RFI #91: Top Mat Rebar Spacing

FIRST FLOOR EAST
REINFORCING PLAN

S-106.2

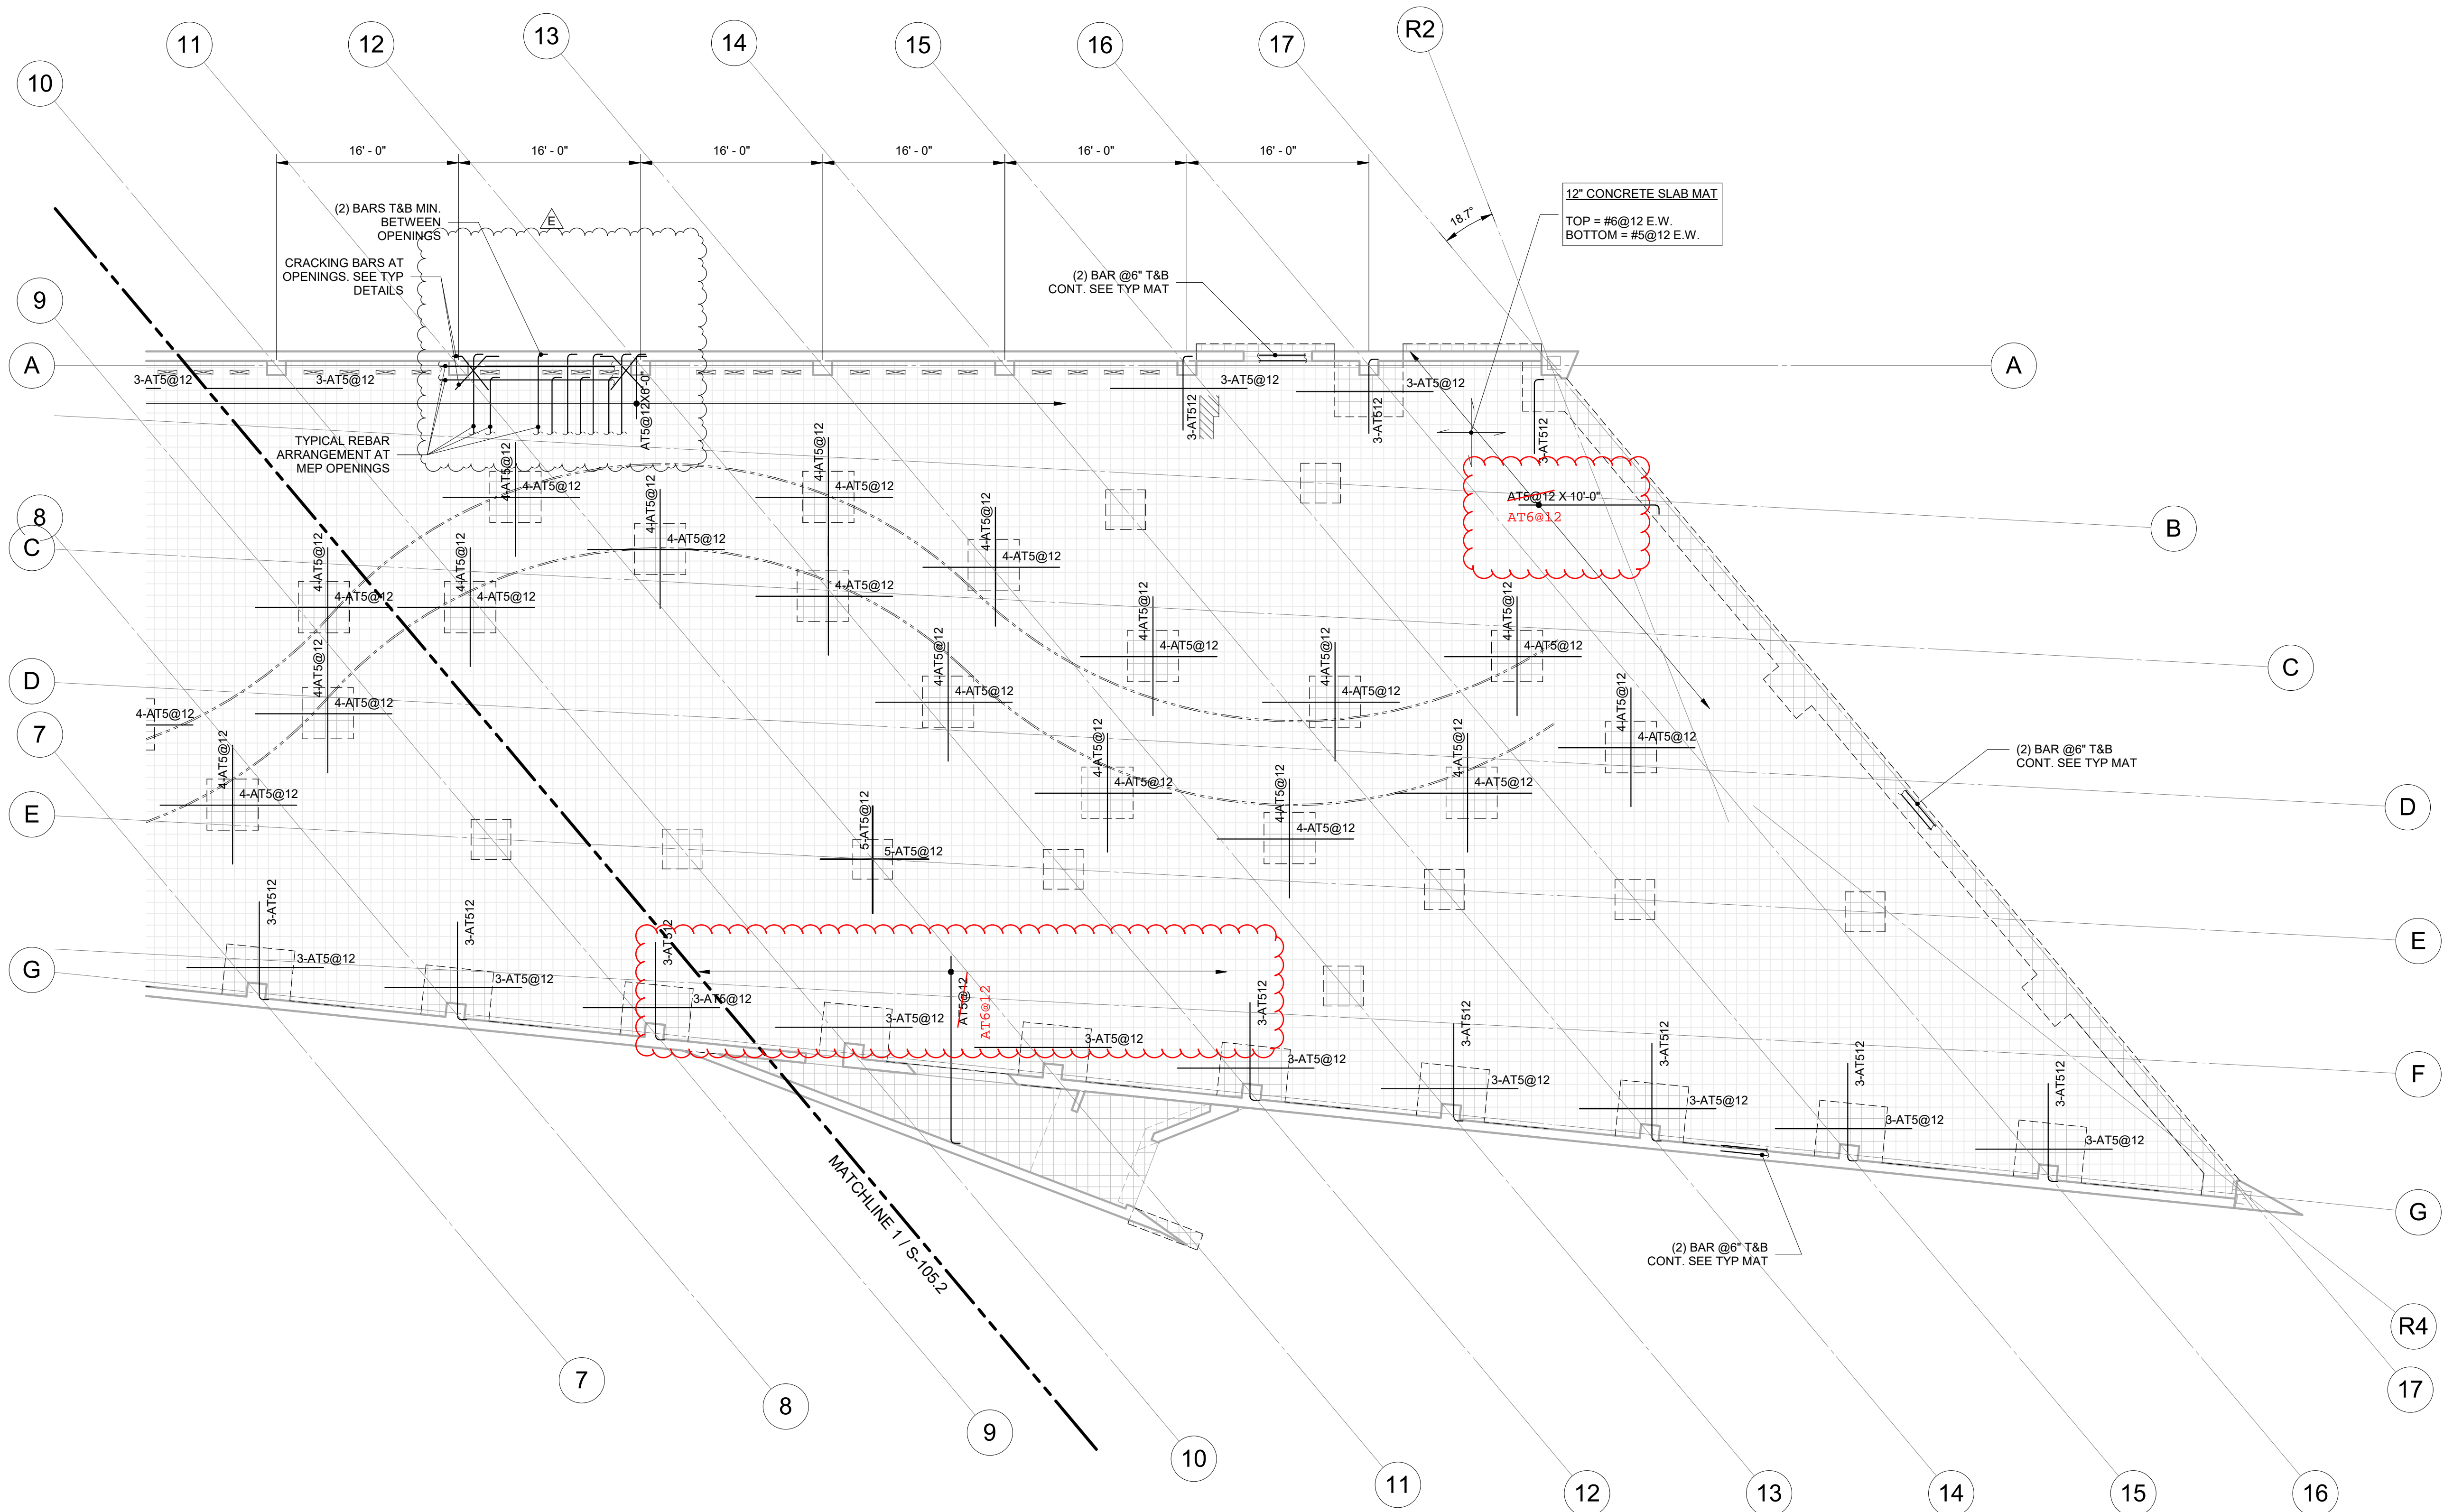
Per LERA response on RFI #61, we are electing to lower the top mat of rebar to 2" cover. LERA, please confirm the following:

1. Per RFI #61 between Grid lines 9-12.5 above the south vestibule, between grid lines 16-17 in the northeast corner, and between Grid lines 7-8 below the north vestibule show areas that the Rebar size needs to be increased from a #5 to a #6. Please confirm the exact locations that we need to change the rebar from #5 to #6 as well as any rebar spacing that needs to change.
